ADDENDUM NO. 1
SEWER SYSTEM IMPROVEMENTS
CONTRACT 18-01
WATER TREATMENT PLANT IMPROVEMENTS
LIVINGSTON, TENNESSEE
WAUFORD PROJECT NUMBER 2068

Date of Addendum: Friday, June 8, 2018
Bid Opening: Thursday, June 14, 2018, 2:00 P.M. Central Time

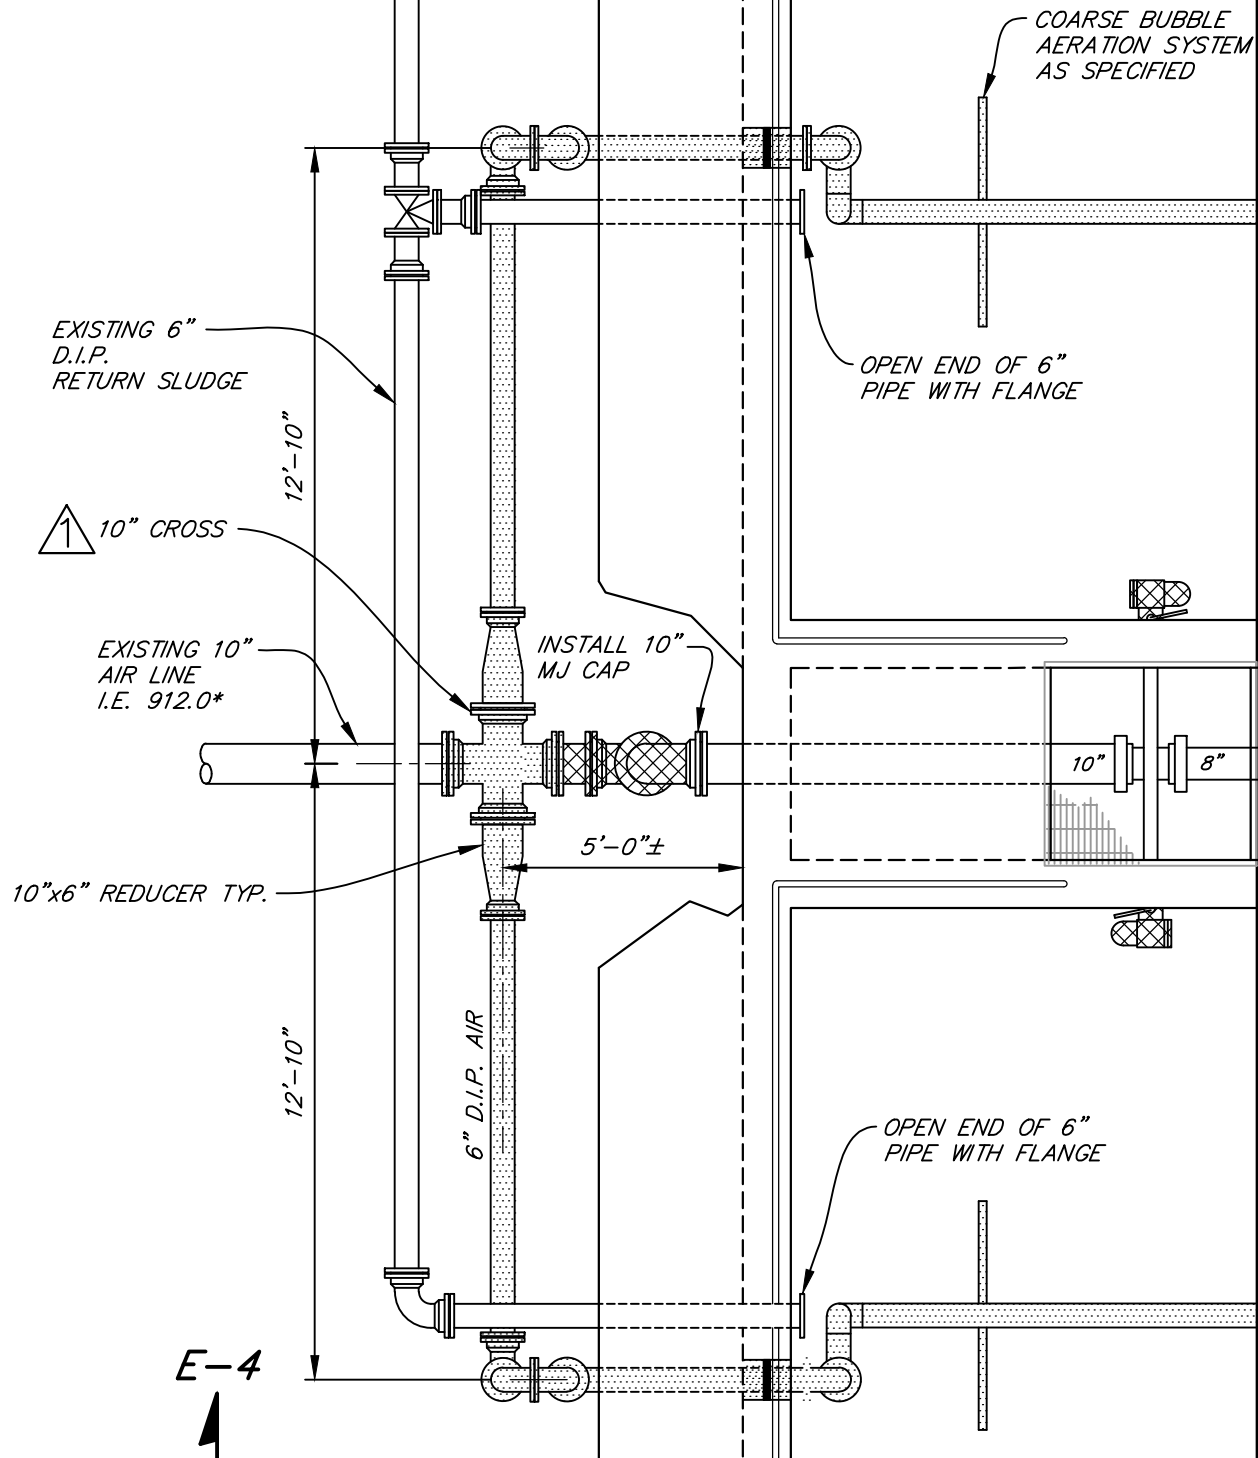
6. Plans, Sheet 4:

Modify as shown on the three attached 8 ½" x 11" sheets.
